# Access Compliance Report

## Public Rights-of-Way

### (Curb Ramps)

Intersection ID: 29130	Main Street: APPLEDALE_DR	Cross Street: COVELO_CT	Location:	N
ADA ID: 60492311B9BB	Ramp Type: PerpDiag	Initial Pass/Fail: Pass	Overall Compliance: No	Severity Score: 27.5
Codes/Mitigation Info/Possible Solution		Field Measurements/Component Compliance

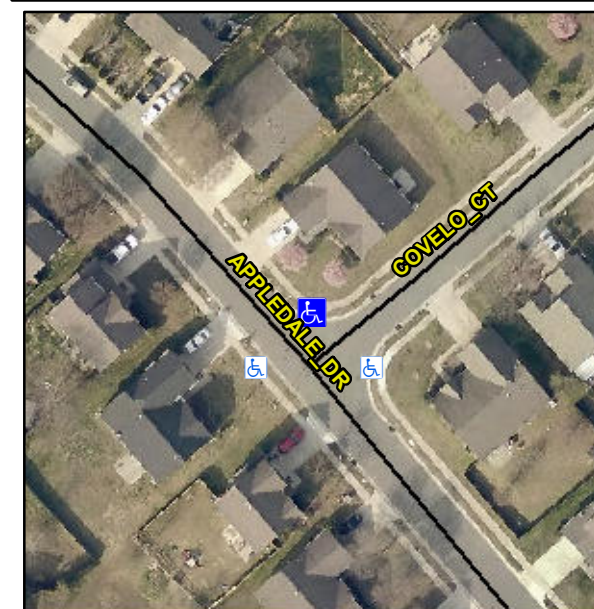
**Not Found, R304.2.1, R304.2.2-Perp, R304.3.2-Para, R304.5.3, R305, R302.7.2**

**Remove & Replace Curb Ramp With Two New Directional Ramps or Equivalent. Remove & Replace Gutter.**
